UNITED STATES PATENT AND TRADEMARK OFFICE

Office Action Summary

10/003,308

DREVIK ET AL.

FIG. 1

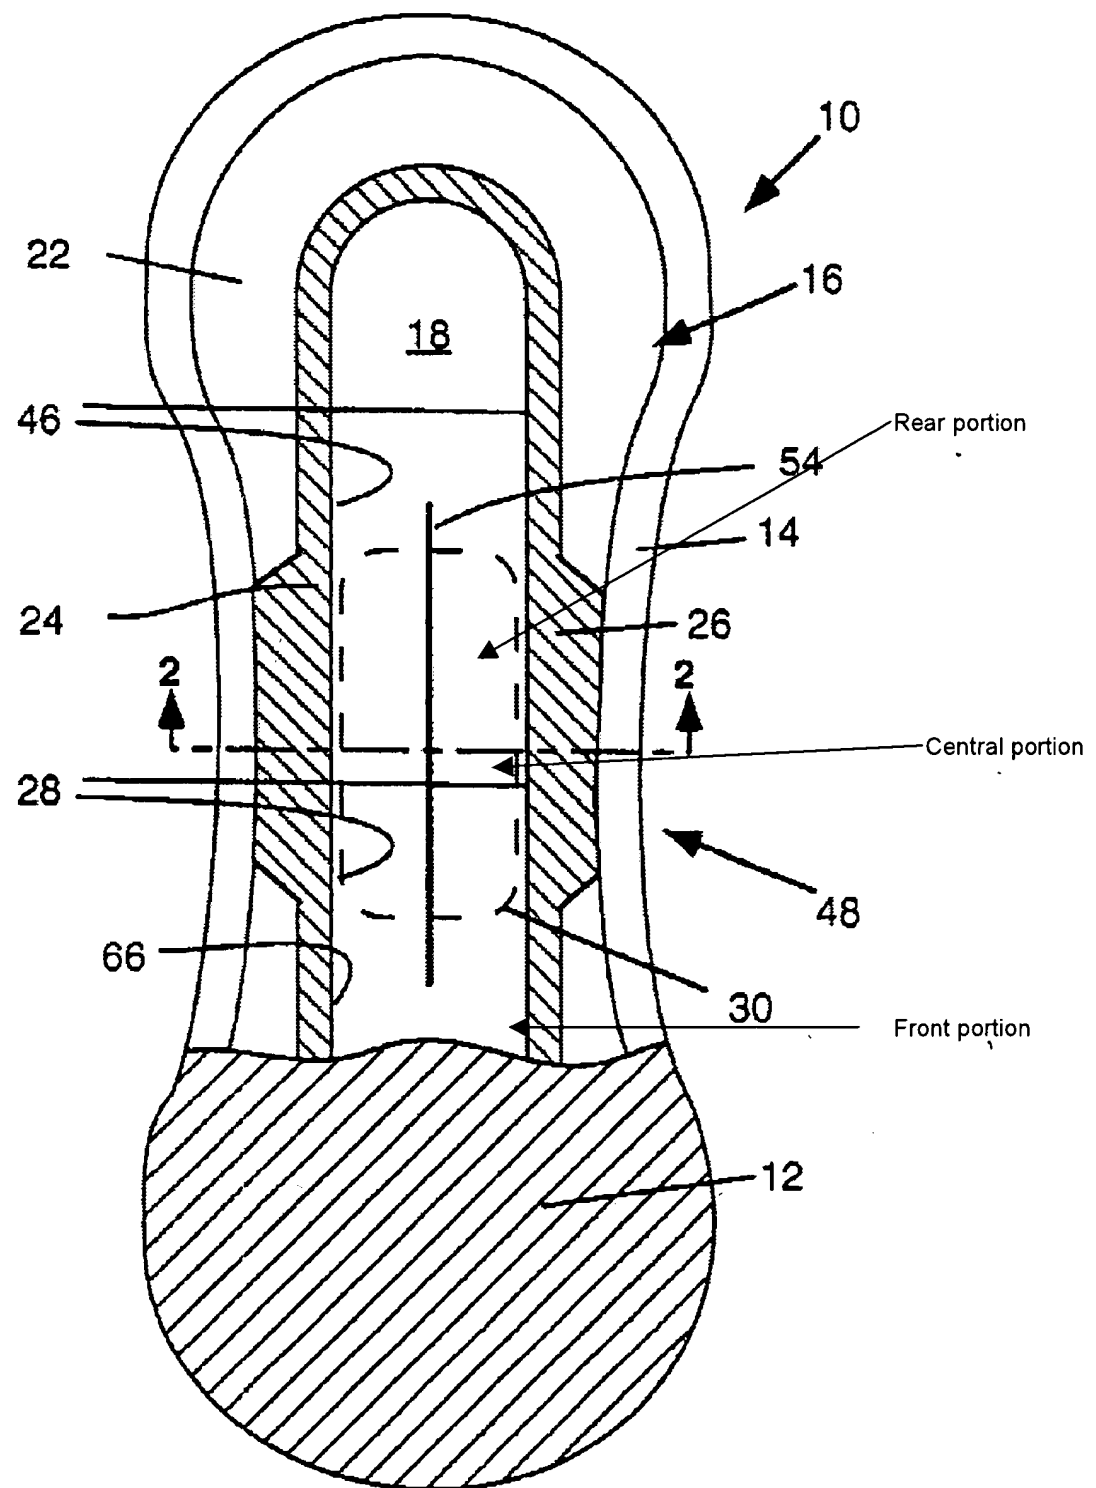
In response to the applicant's arguments that Chen does not disclose a split rear portion, the examiner refers to figure 1 as shown below.

Figure 1 shows what is considered as the front, central and rear portions. The elastic member (30) extends through all of these regions as does element (54) designating the split portion in these regions (see figures 1, 6 and 9). Therefore, Chen does provide the layer (18) split into two legs (in the area represented by 54) in a rear portion.
